SUBJECT: Forwards addl info on proposed license amend re boric acid concentration reduction, per NRC 880310 request.

Re: St. Lucie Unit 1
Docket No. 50-335
Request for Additional Information -
Boric Acid Concentration Reduction

ST. LUCIE UNIT 1
BORIC ACID CONCENTRATION REDUCTION

FPL RESPONSE TO NRC REQUEST FOR ADDITIONAL INFORMATION

V. FIGURE 3.1-1

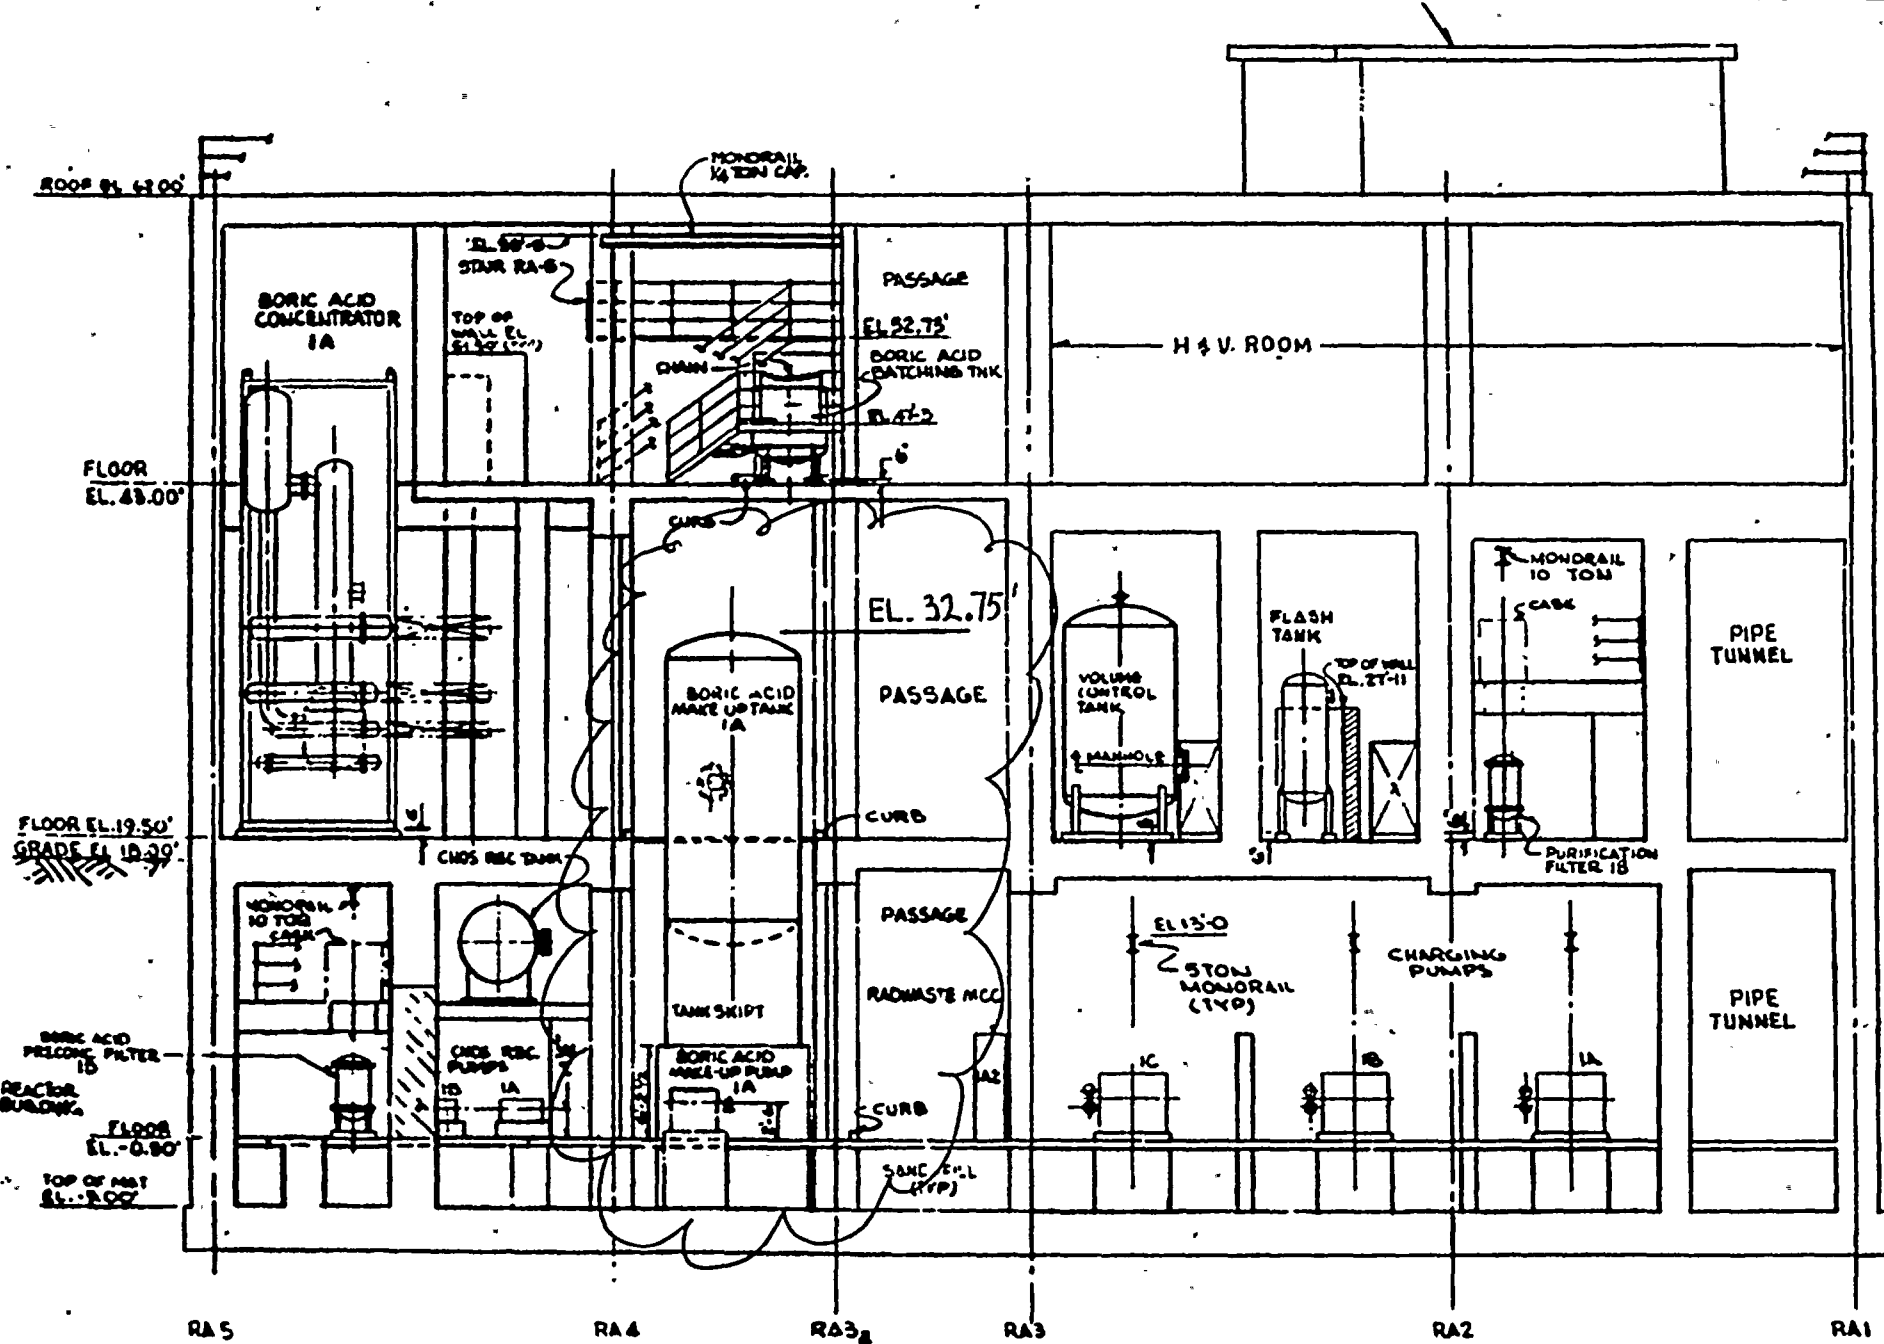
In regard to proposed Figure 3.1-1, please explain why it is necessary to have at the bottom of the figure the expression "1720 ppm in the RWT."

We have reviewed Figure 3.1-1 and have determined that the expression "1720 ppm in the RWT" at the bottom of the figure is not necessary. Therefore, we propose to remove this expression (See attached revised Figure 3.1-1).
